1207 PLOT 9B FIRST STREET, MANCHESTER

NMA APPLICATION REPORT

1207-TGA-XX-XX-RP-A-FI_10_10-00400 P01

TIM GROOM ARCHITECTS

Ventilation Strategy
Elevation Amendment - East and West

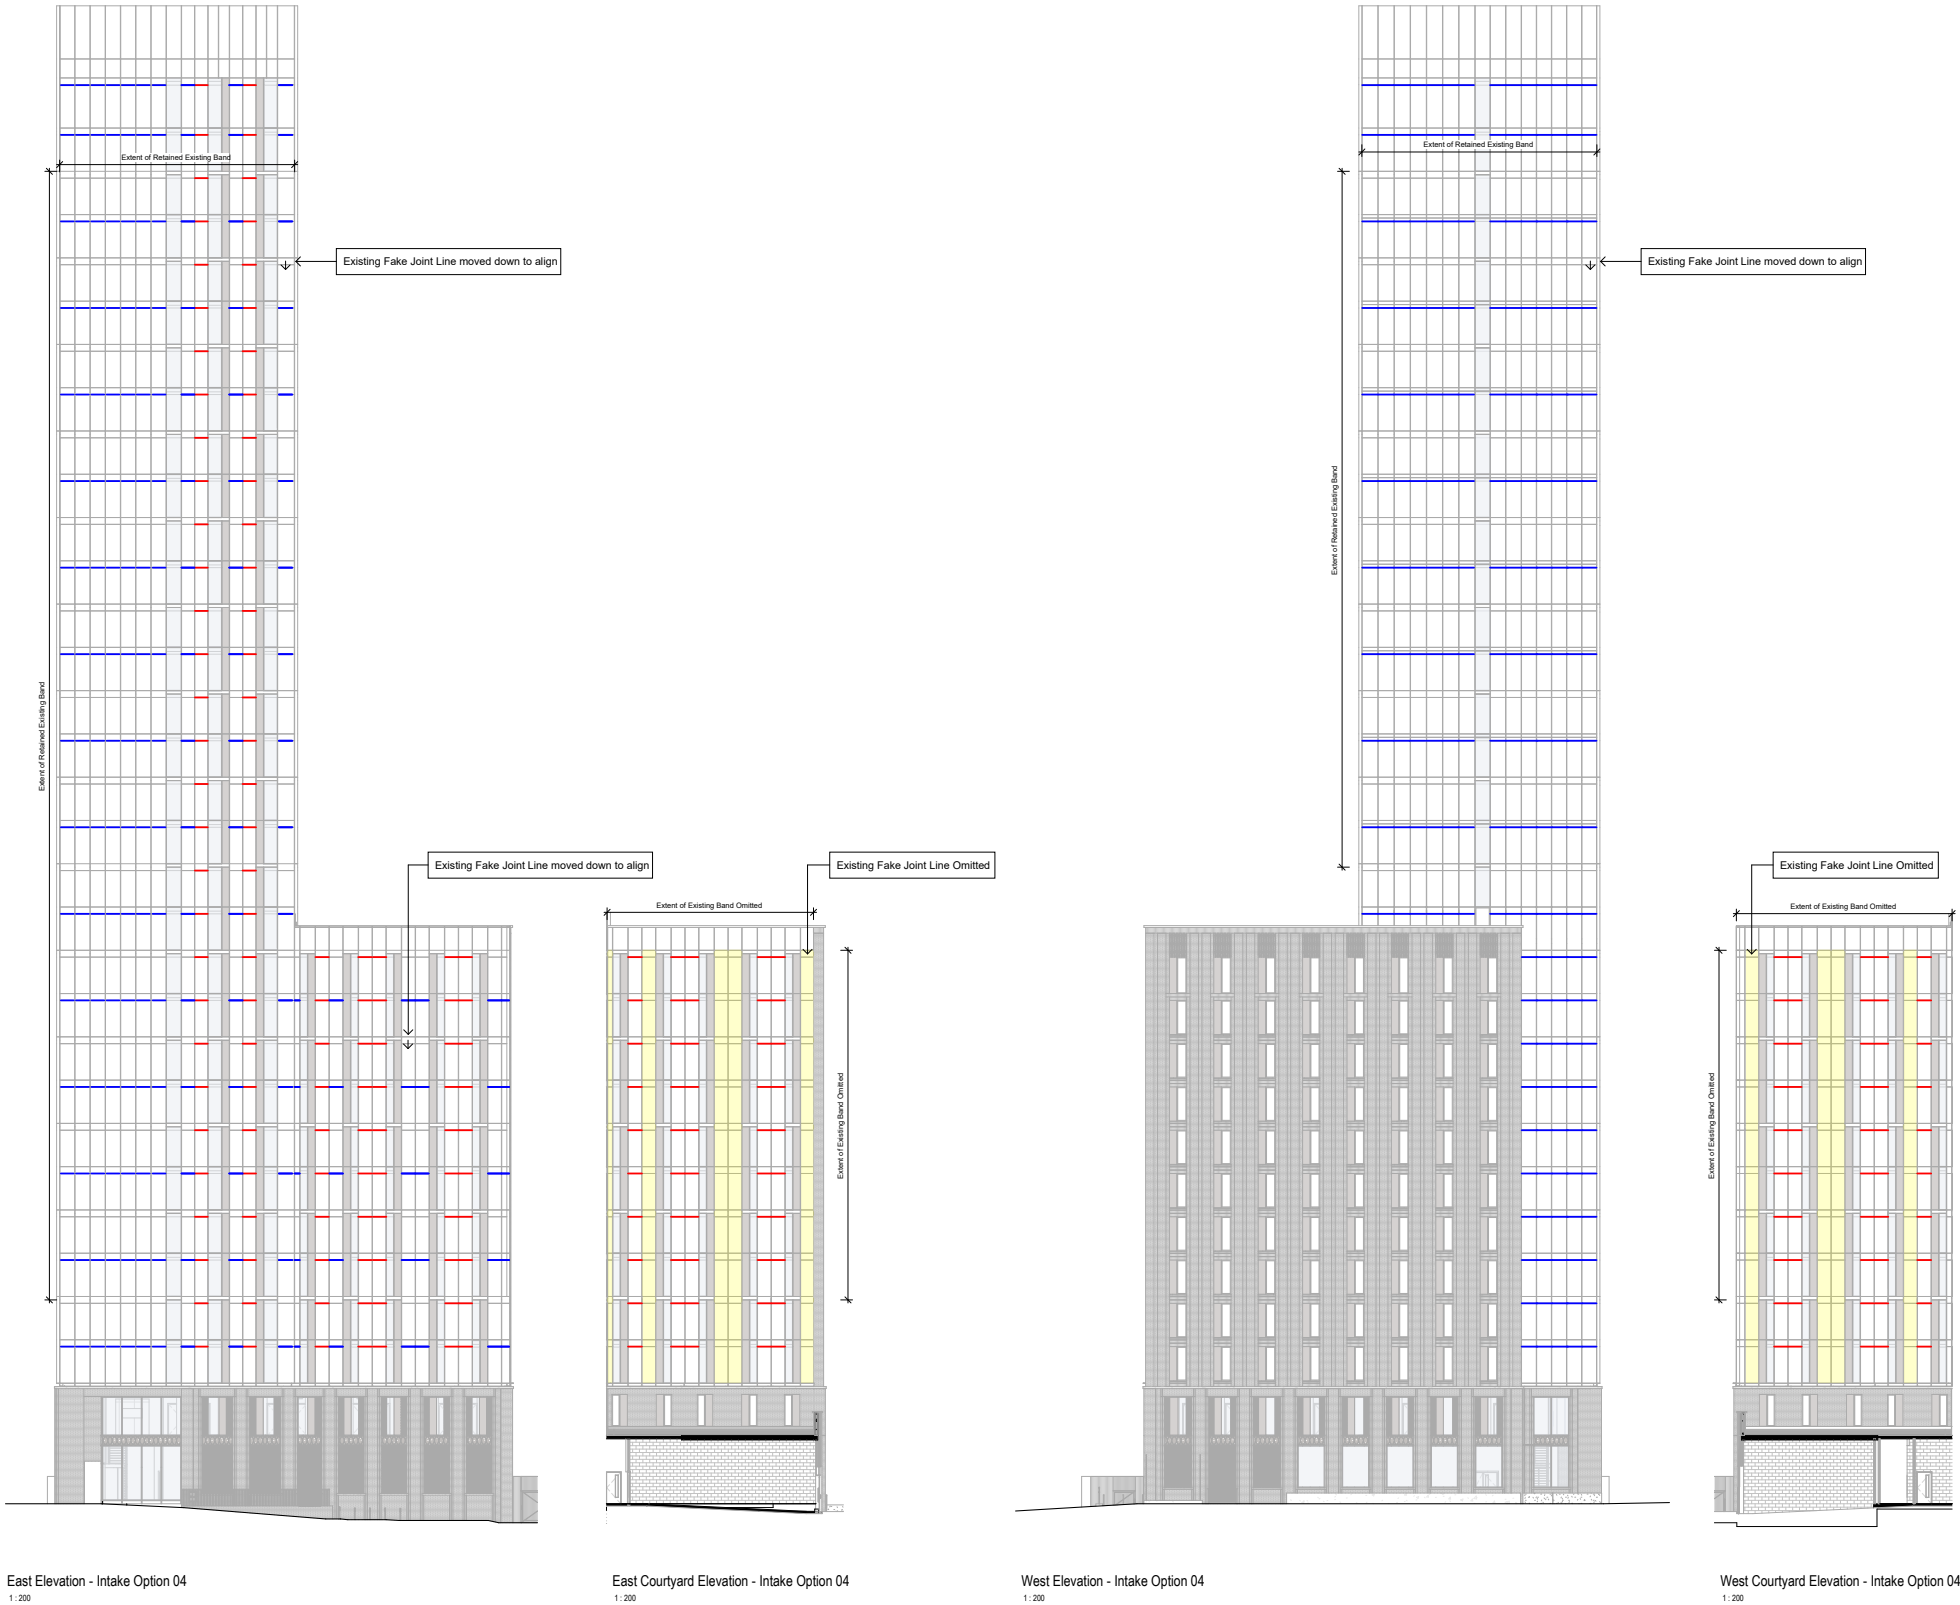
The required addition of the extra panel joint to accommodate the vent has resulted in the adaptation of the existing horizontal banding arrangement across the facade.

It is proposed that the existing banding line is dropped to align with the slot vent height and an additional banding line incorporated at other levels to provide a holistic and integral composition across the facade.

The only proposed exception to this rule is to the courtyard areas where the elevations are not visible from street level. The horizontal banding has been omitted from these areas.

The drawings opposite illustrate the proposed amendments to the East and West Elevations.

Ventilation Strategy
Elevation Amendment - North and South

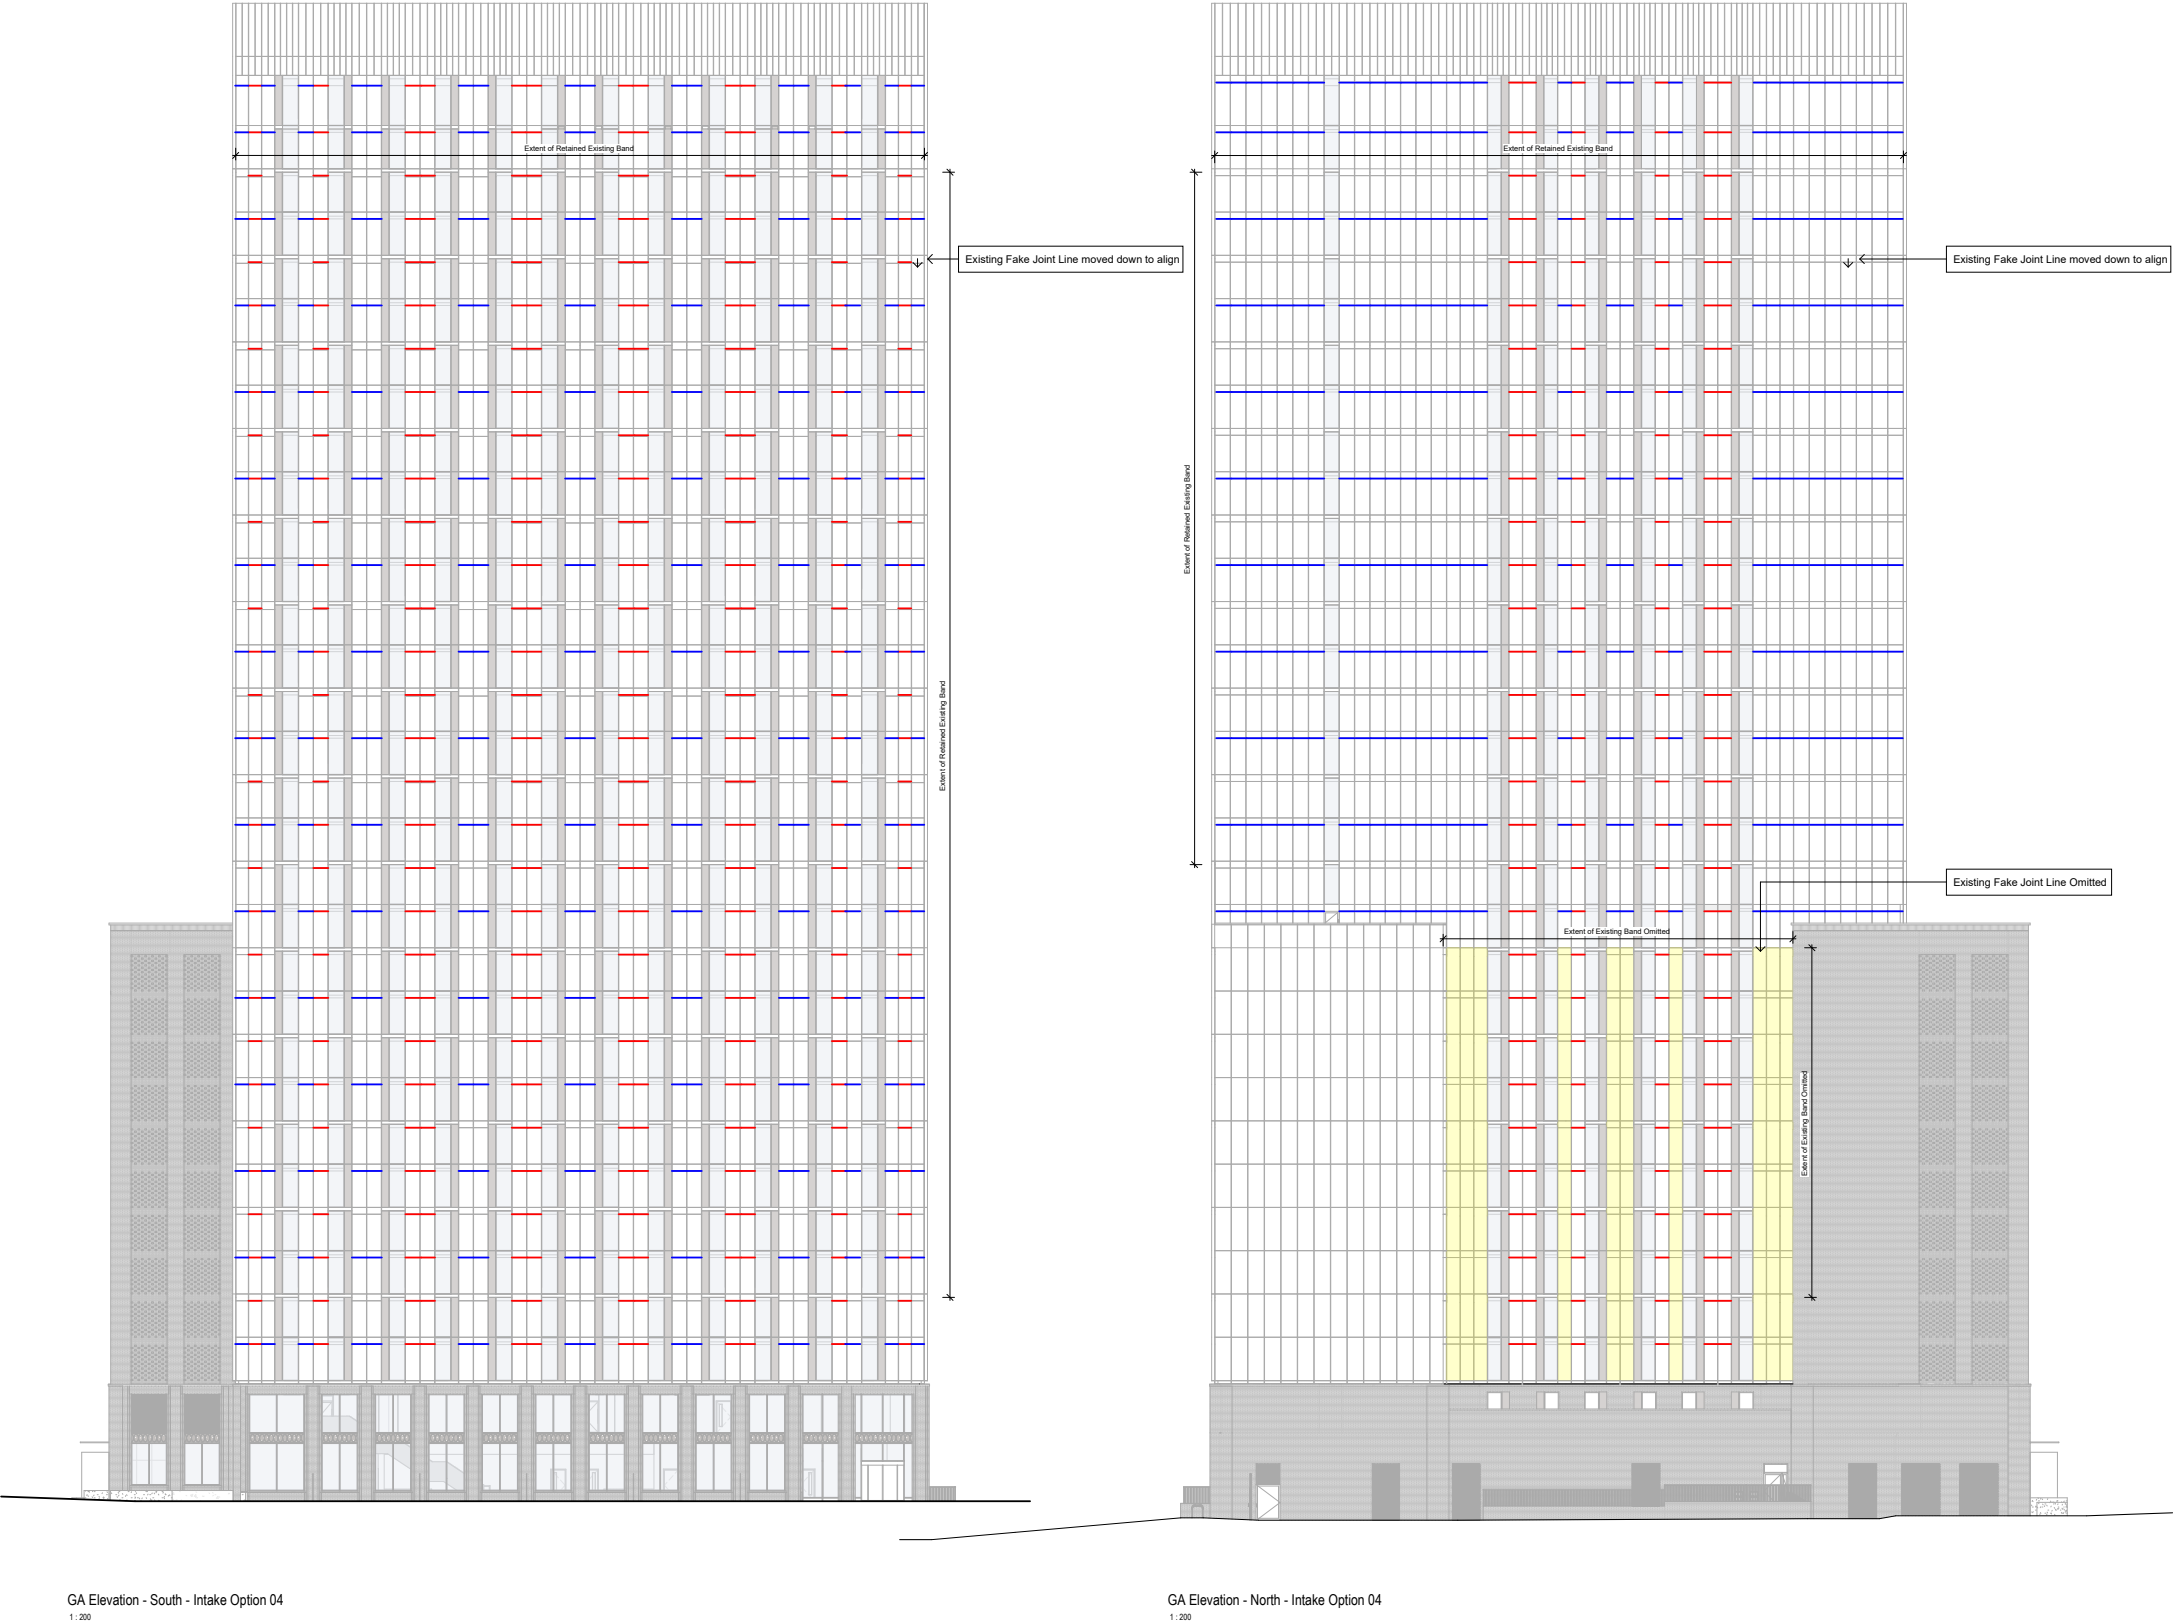
The drawings opposite illustrate the proposed amendments to the North and South Elevations.

Approved Planning Drawing - VS9B-TGA-G251-DE-XX-95217

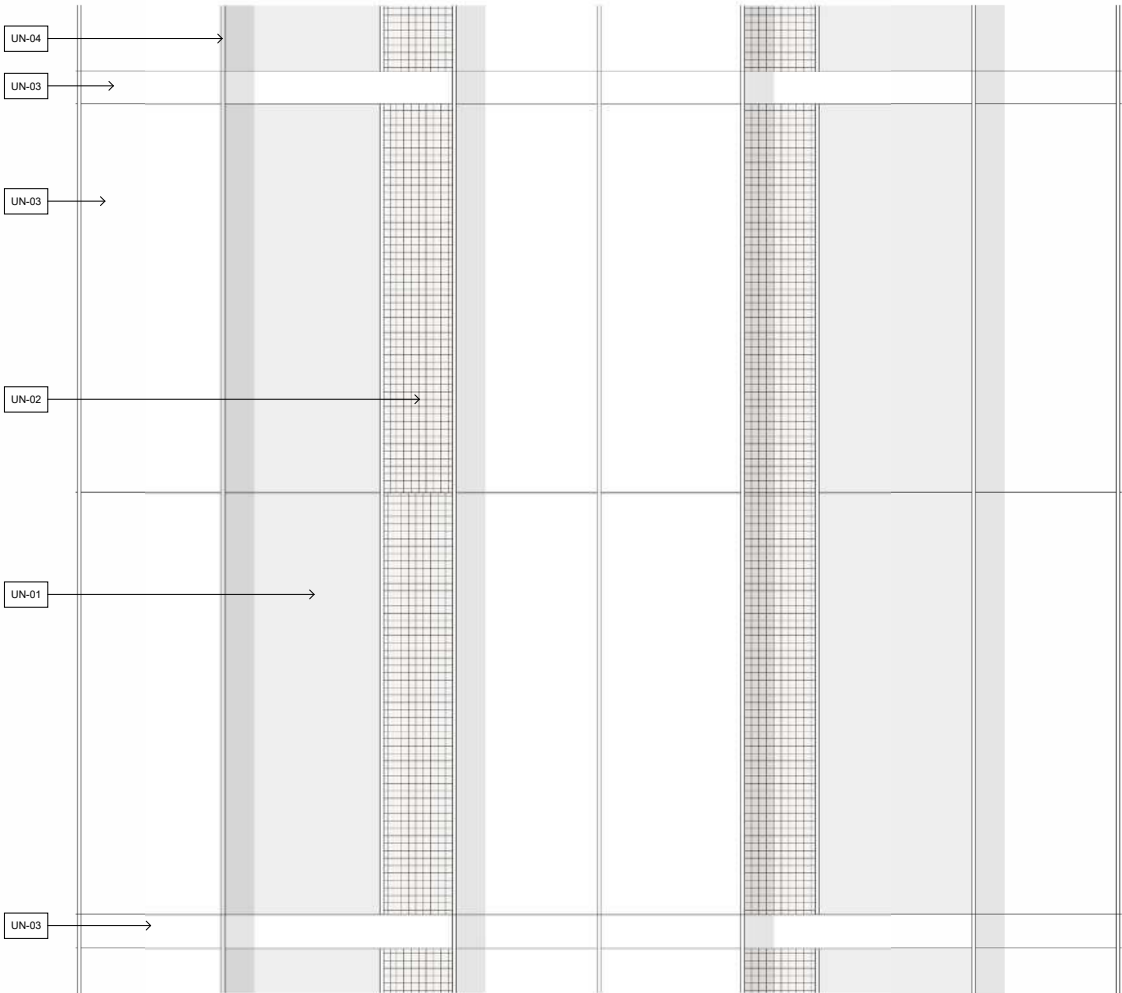
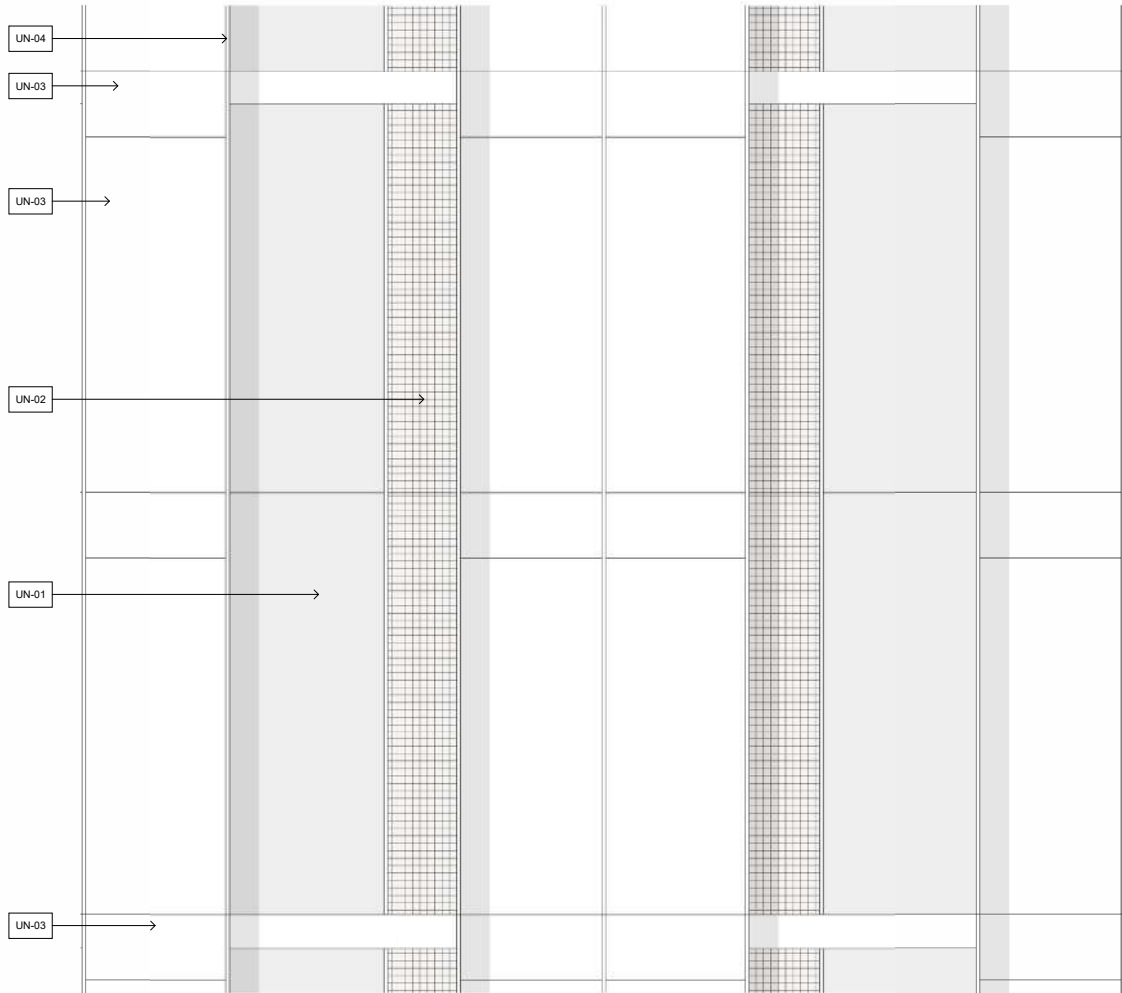
Proposed Revised Drawing

Approved Planning Drawing - VS9B-TGA-G251-DE-XX-95218

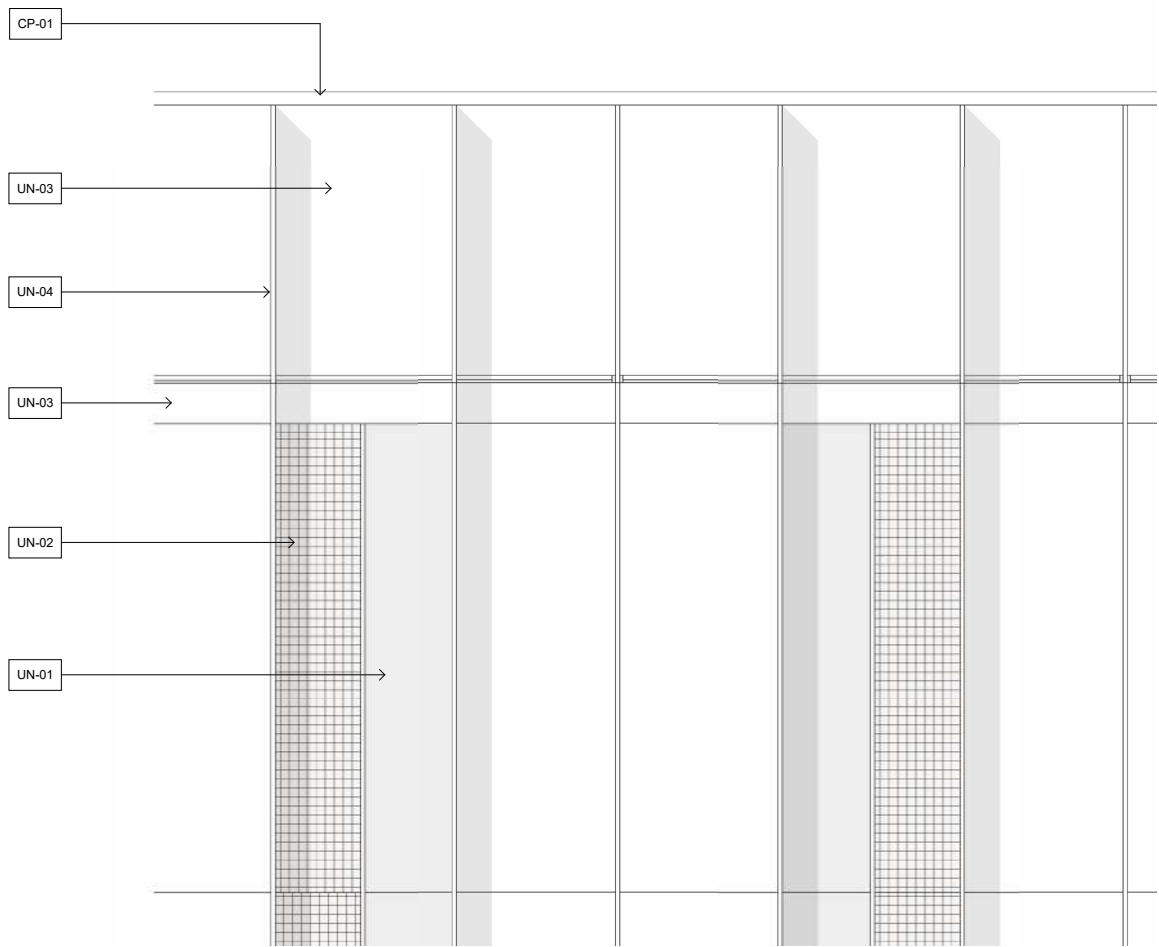
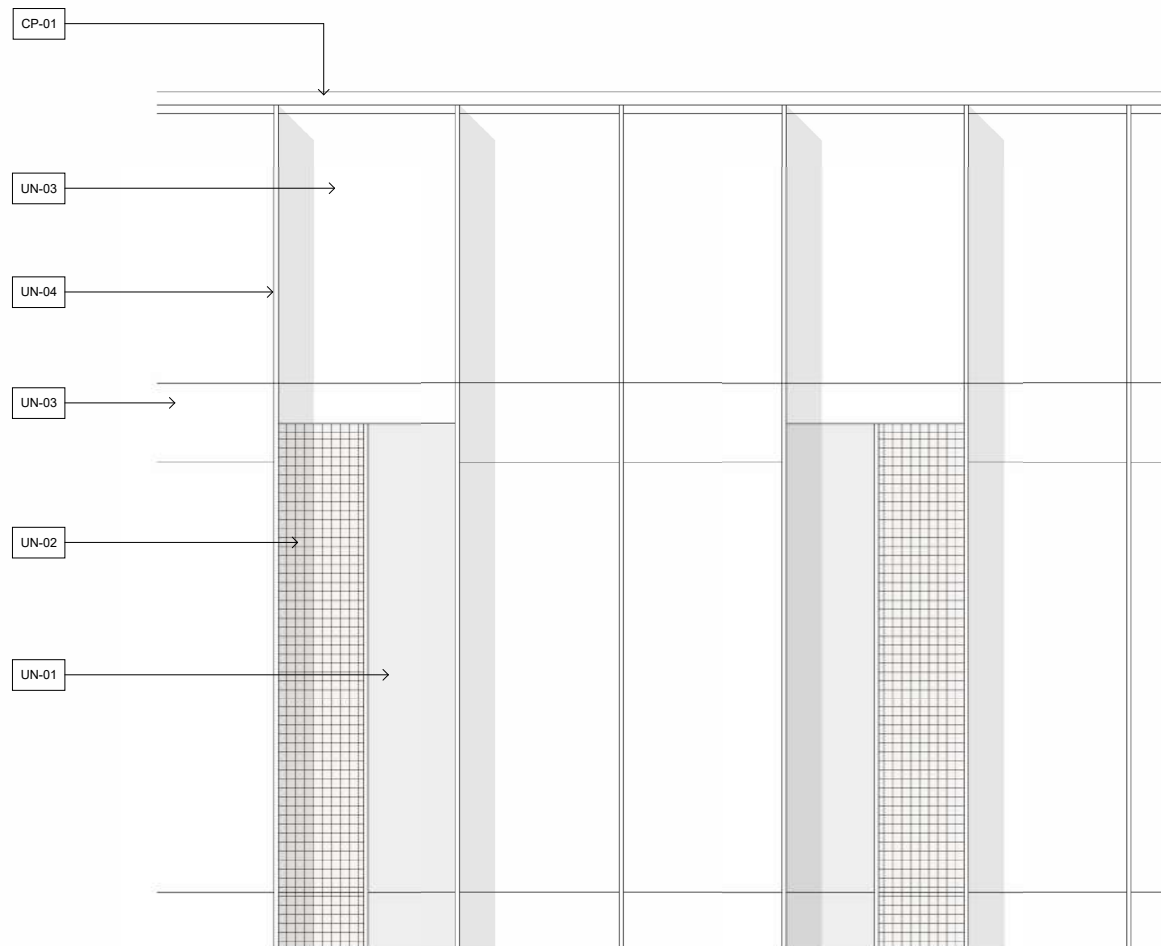
Proposed Revised Drawing
